DOCKET
11-IEP-1C
DATE <u>May 18 2011</u>
RECD. <u>May 24 2011</u>

RE: Comments on CEC's Estimates of Energy Efficiency in the Demand Forecast

ATTACHMENT A: KEY ISSUES AND CONCERNS REGARDING CEC DEMAND FORECAST

Figure 1. Energy Efficiency/Conservation Consumption Savings³ (2005 CEC Publication)

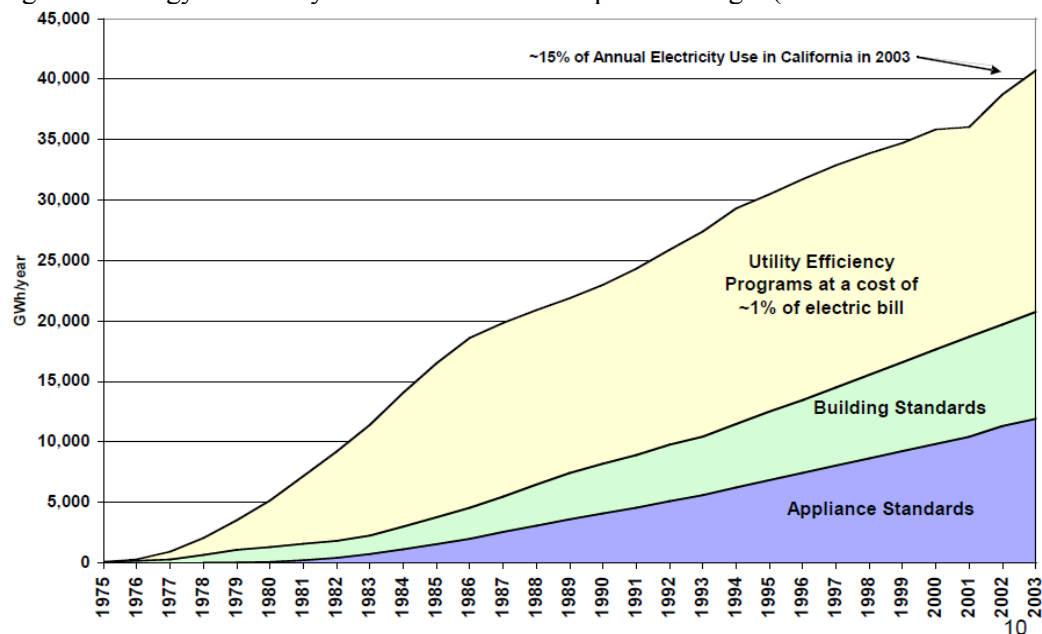
For reference, below are the 2005 and 2009 CEC publications of historical program savings. Figure 1 depicts the graph that was used for the years leading up to IEPR 2009. The figure does not disaggregate naturally occurring savings from efficiency programs. These numbers are consistent with estimates from our Northwest counterparts, who have shared similar commitments to efficiency programs and codes and standards work over the decades, as depicted by Figure 2.

Figure 3 *Energy Efficiency/Conservation Consumption Savings (2009 CEC Publication)*⁵

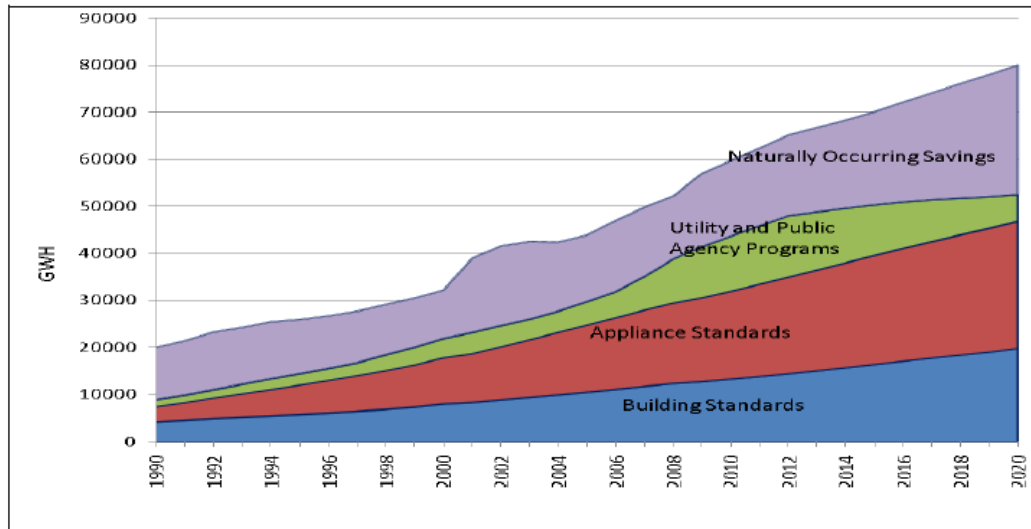
- The revised graphical depiction of the sources of energy savings, which previously showed roughly equal wedges for historic savings from utility programs and codes and standards, is highly misleading in its seeming replacement of the majority of the utility program savings wedge with “naturally occurring savings.” This change from previous depictions of this graph stands to be extremely confusing to the public, both inside and outside of California. The more recent graph does not promote confidence in the relative contribution of each source of efficiency savings, while both are essential components of California’s energy efficiency policy.

Ultimately, the Efficiency Council is very concerned about the underlying message, or perceived message, of the most recent CEC graph of historical energy efficiency impacts. Without further explanation of what “naturally occurring savings” may mean, the graph risks implying to the casual observer that a laissez-faire approach to energy efficiency, in which efficiency programs are unnecessary, is significantly more effectual than sustained investment in efficiency programs to overcome market barriers to wide-spread adoption of energy efficiency. This argument is diametrically opposed to an abundance of academic literature that describes the various market failures associated with energy efficiency, and the need for policy and program invention to address them.¹ In addition, the conclusion that efficiency programs are unnecessary, which some may reach after seeing the revised graph, is contrary to the experiences of our member companies who have found their programs to be successful in motivating customers to make energy efficiency improvements and providing substantial energy and bill savings to those customers.

Thus, it is disconcerting that the CEC’s revised graph released in the 2009 CEC Demand Forecast publication would radically diverge from these results, as depicted in Figure 3. Here, the graph reflects savings attributed to a new category of savings due to naturally occurring causes, which is implied to be mutually exclusive to the original categories but also seems to drastically reduce utility program contributions.

- The final demand forecast should utilize a single total estimate of energy savings since the current model is not suited to identify and parse the causes associated with savings.
- If the CEC does attempt to include the parsed energy-efficiency savings graph, it should be done in a highly transparent manner. The CEC should provide confidence intervals for their estimates and acknowledge issues like the discrepancy in results based on what the model inputs first, and as well as price and program entanglement effects.
- Conduct sensitivity analyses on the most uncertain factors associated with both the savings from energy efficiency and the demand forecast to assess the magnitude of the impact on model results. At a minimum, we suggest the CEC assess sensitivity to price elasticity market and utility program entanglement.
